SENSITIVITY OF SEISMIC HAZARD RESULTS  
AT MILLSTONE TO LLNL STUDY ASSUMPTIONS  
ON ATTENUATION AND SEISMICITY

FINAL REPORT  
TO  
NORTHEAST UTILITIES

# Dames & Moore

June 15, 1984

Figure 24  
 Median Spectral Velocity (9 and 5hz) Hazard Curves  
 (5% Damping), Base Cases,  $m_{b,\text{min}}=4.5$  and 5.0

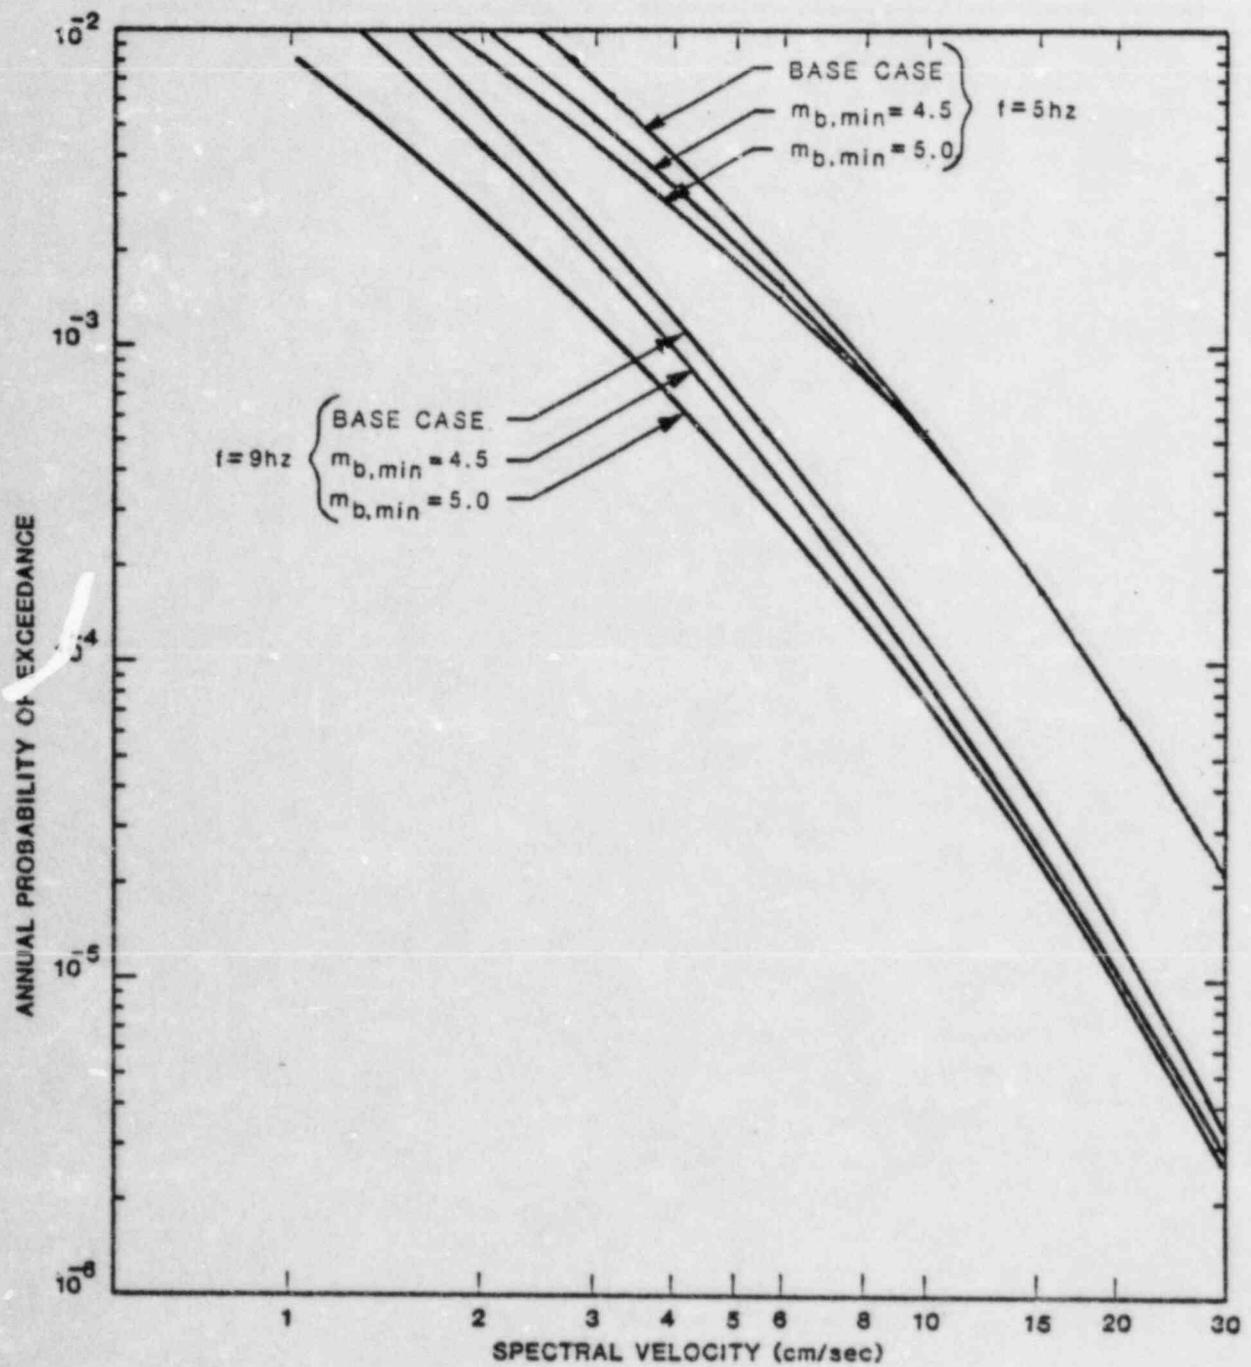
Results for spectral velocities at 9 and 5 hz are shown in Figure 24. The 9 hz results lead to the same conclusions as for acceleration, namely that the use of  $m_{b,max} = 3.75$  is extremely conservative over more realistic alterna-

tives, by a factor of 15% to 25% in spectral velocity. For 5 hz, spectral velocity is governed by the ground-velocity-amplified portion of the response spectrum for magnitudes below  $m_b = 5$ , and these contribute little to the seismic hazard results, so the curves are not sensitive to the choice of lower bound for spectral velocities below about 10 cm/sec.

Figure 25  
Acceleration Hazard Curves

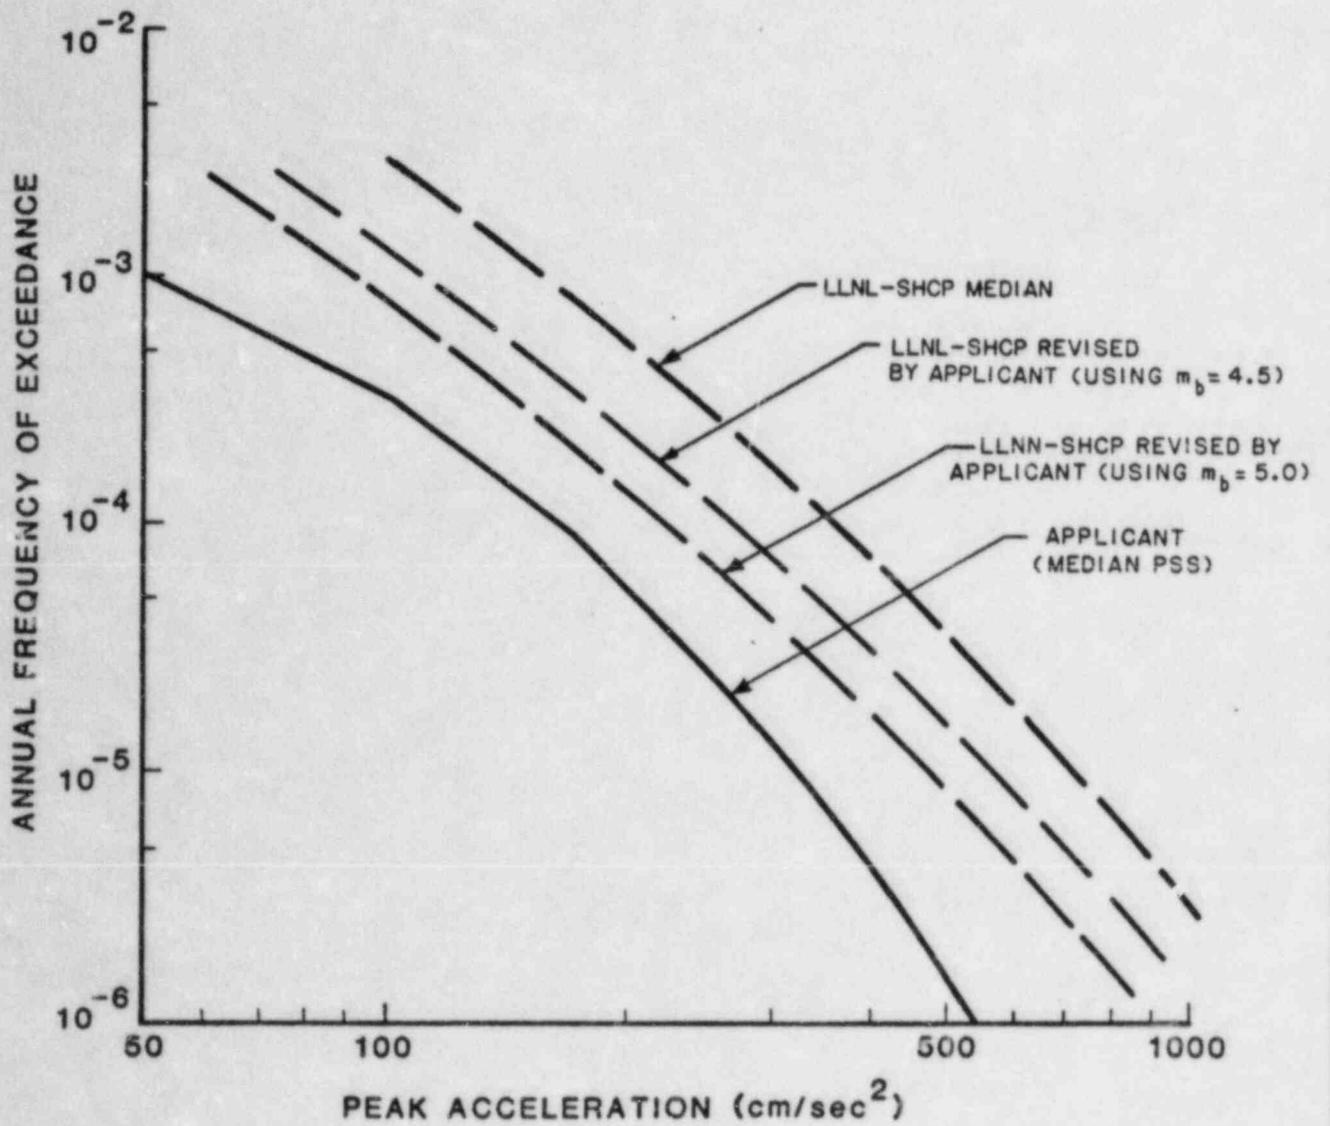
Thus, removing the major conservatisms identified in a preliminary review of the LLNL work means that the spectral amplitudes for a given probability level would decrease significantly. A visual representation of the effect is shown on Figure 25. The peak ground acceleration hazard curve developed by Northeast Utilities is shown as the solid line, and compared to it are several original and revised hazard curves from the LLNL study. The long-dashed curves (labeled "SHCP" for "Seismic Hazard Characterization Program") are LLNL median curves, as originally published and as revised by reducing the accelerations at a given probability level by the reductions shown in Figures 16, 21, and 23 to

remove conservatisms. The revised median curve lies much closer to the Northeast Utilities' result: at the SSE level the two curves agree within a factor of 2 in probability.

Figure 26  
Acceleration Hazard Curves

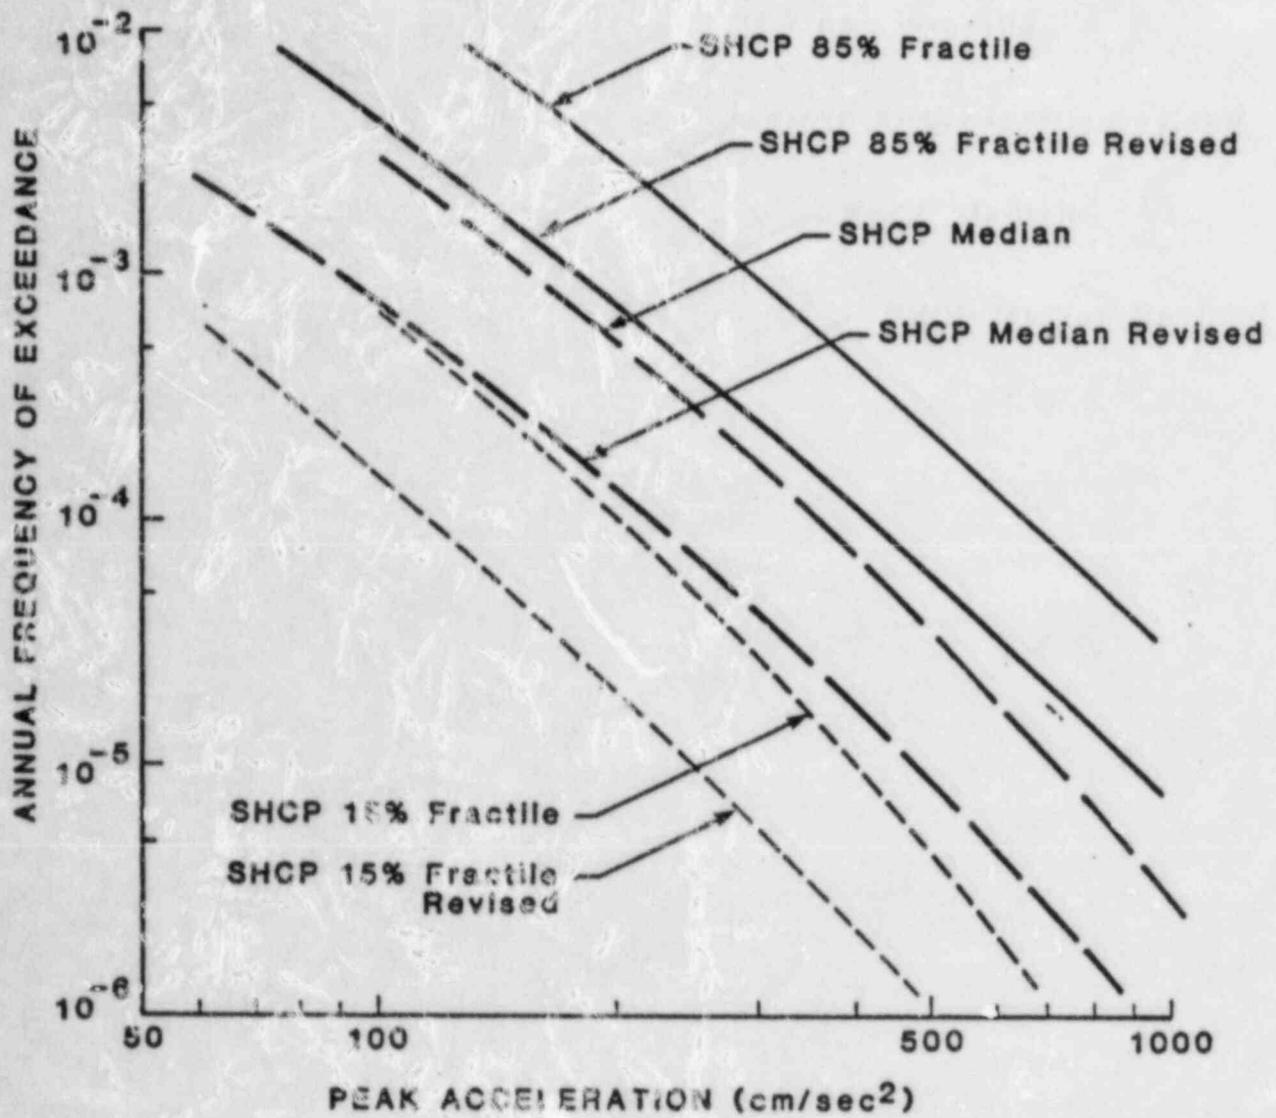
Figure 26 shows original and revised hazard curves from the LLNL-SHCP study, for three fractiles (the median, 15%, and 85%). This shows that the original LLNL-SHCP median curve lies almost at the revised 85% fractile curve, illustrating the conservatism associated with the preliminary LLNL results.
